Re: Erie Land Company, LLC – Preliminary Plat and PUD Rezoning  
(PP-001038-2019 and PUD-001039-2019)

**Subject: Westerly Preliminary Plat PP-001038-2019 – Resubmittal**  
**Town of Erie, Weld County, CO; CGS Unique No. WE-19-0046\_2**

**TO:** Hannah Hippely  
**FROM:** Charles M. Buck, P.E., PTOE  
**DATE:** January 15, 2020  
**SUBJECT:** Review of Preliminary Plat  
Westerly  
PP-001038-2019  
FHU # 95-190

**TO:** Hannah Hippely  
**FROM:** Charles M. Buck, P.E., PTOE  
**DATE:** April 4, 2019  
**SUBJECT:** Review of Preliminary Plat and Planned Unit Development  
Westerly  
PP-001038-2019 & PUD-1001039-2019  
FHU # 95-190

SHEET 8 OF 16

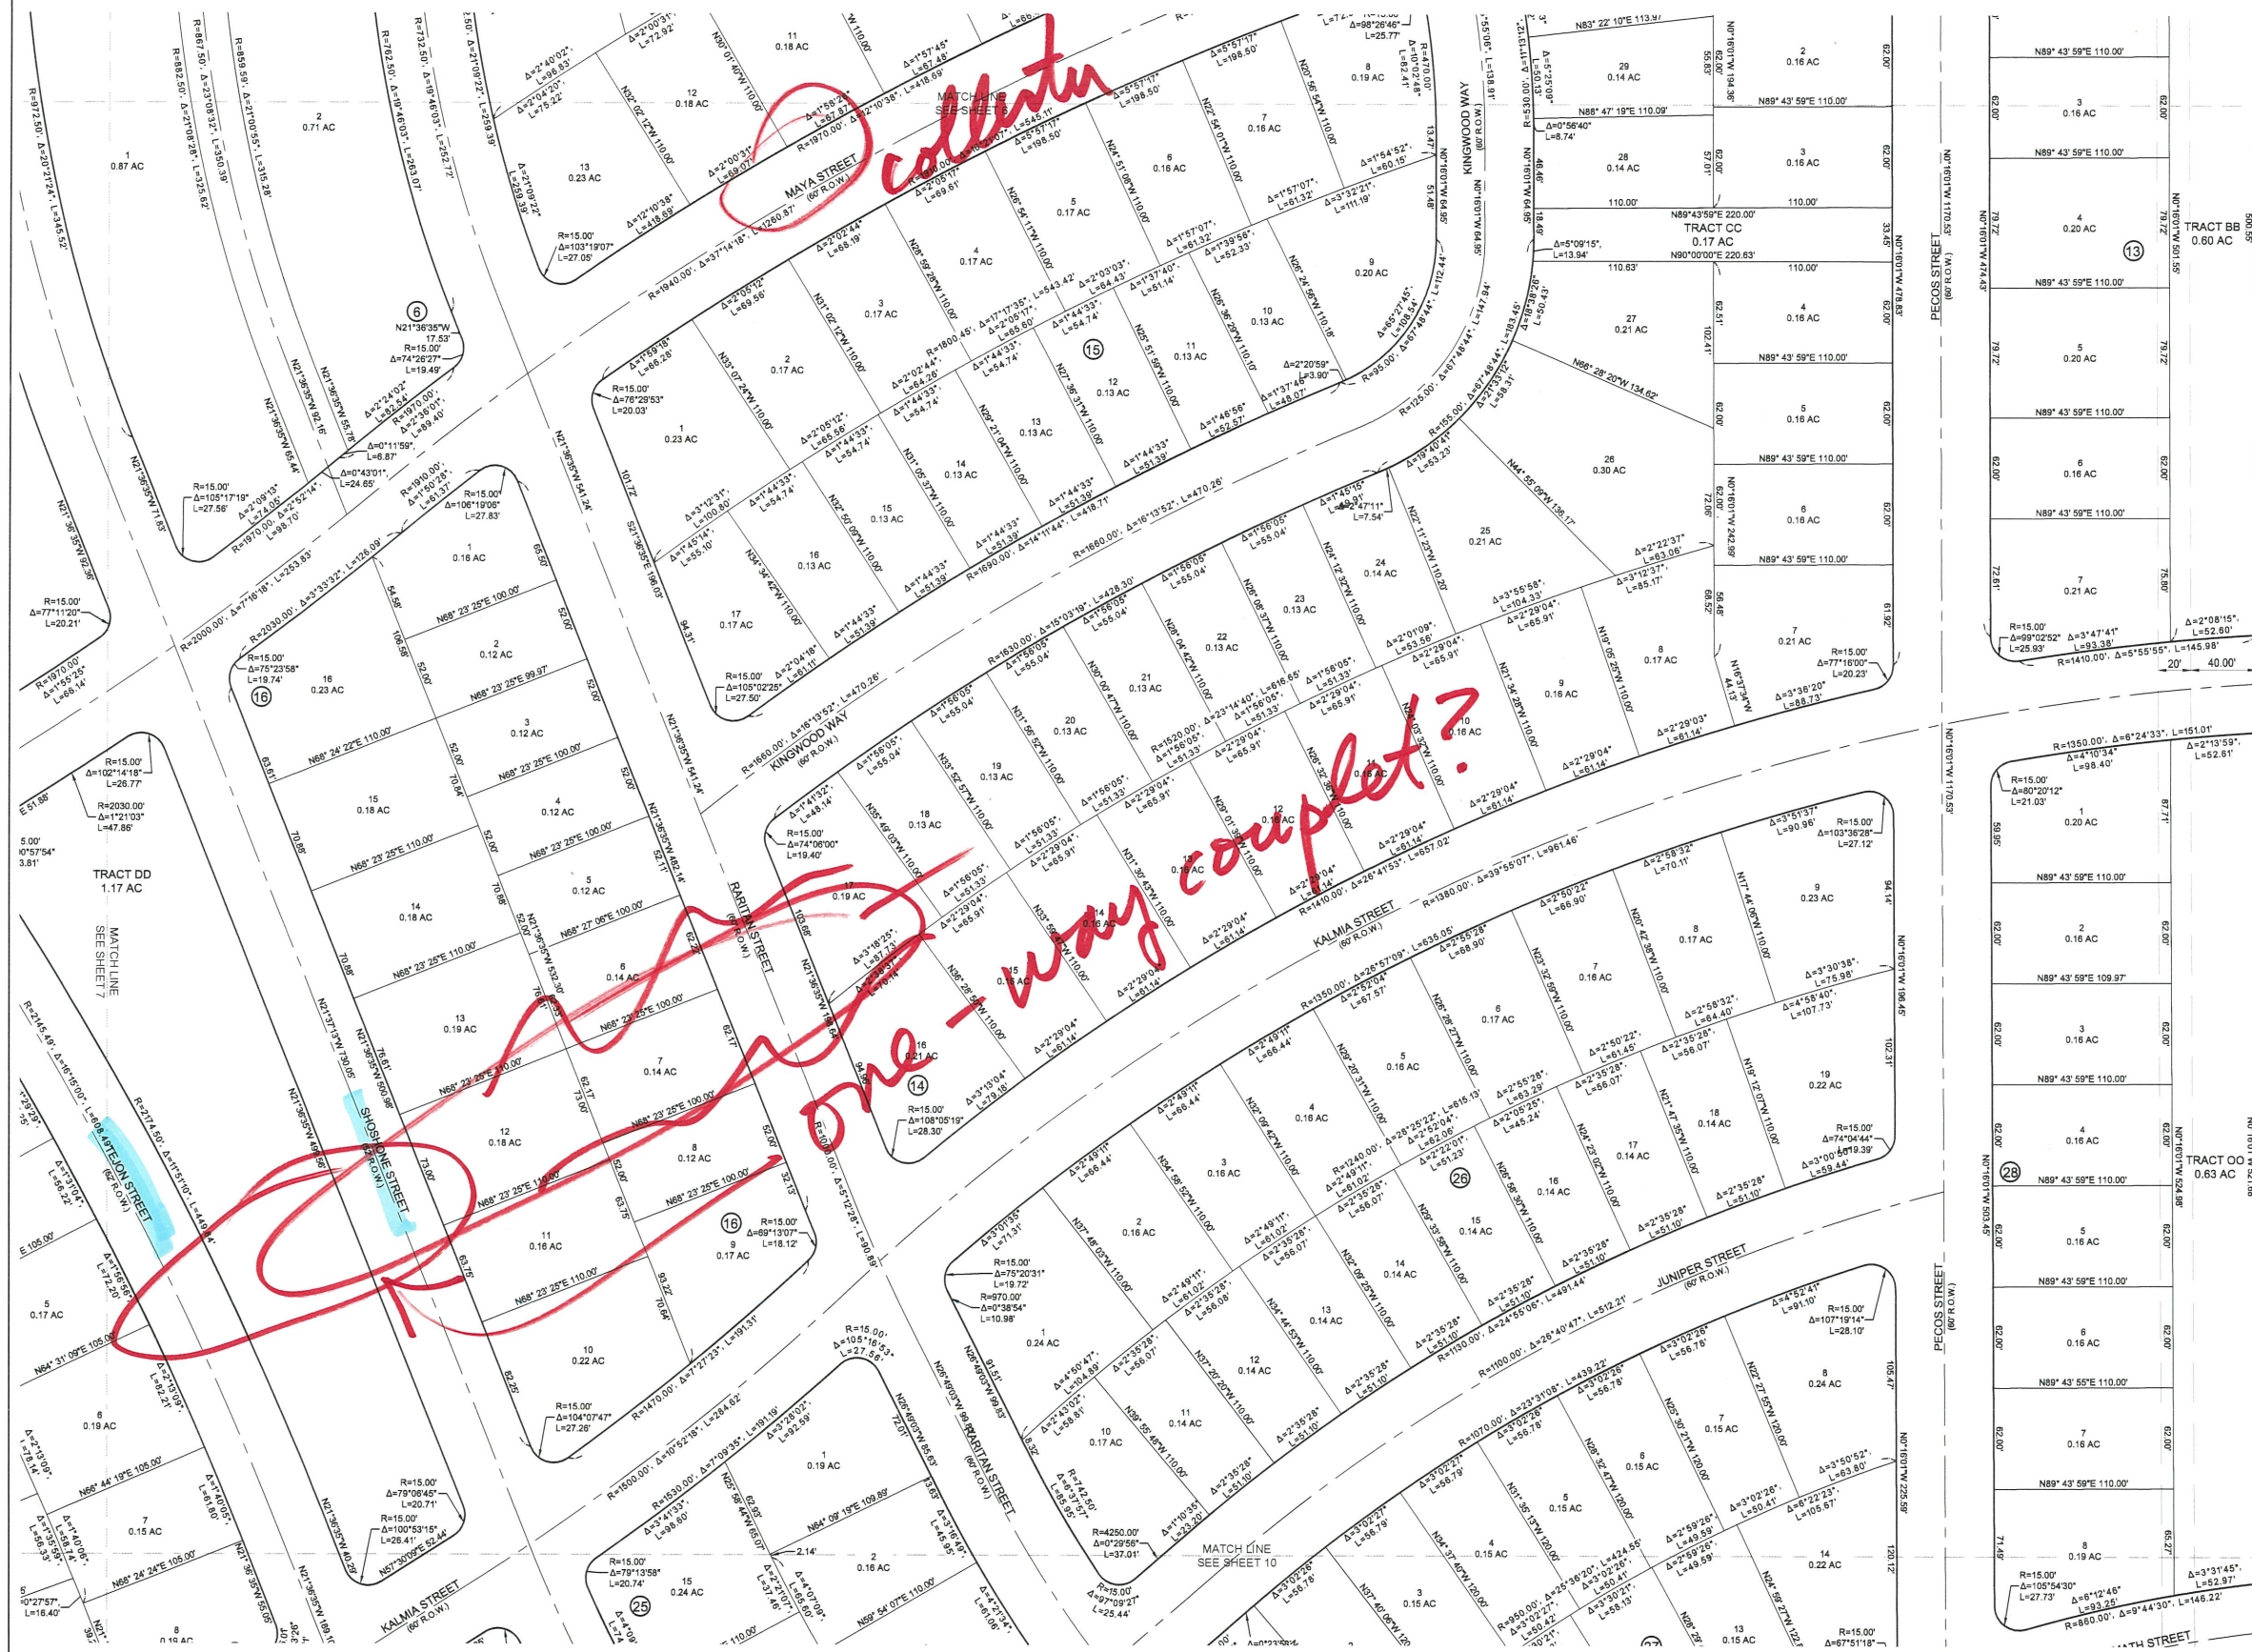
13. Sheet 7 of 16 – See above comment regarding Maya.
14. Sheet 8 of 16 – See above comments # 10 and #13.
15. Sheets 10, 11, and 12 – Hawthorne/Jason is appropriately shown as a collector roadway. I do not object to homes fronting this roadway as long as the traffic volumes are within the 1,000 ADT threshold.
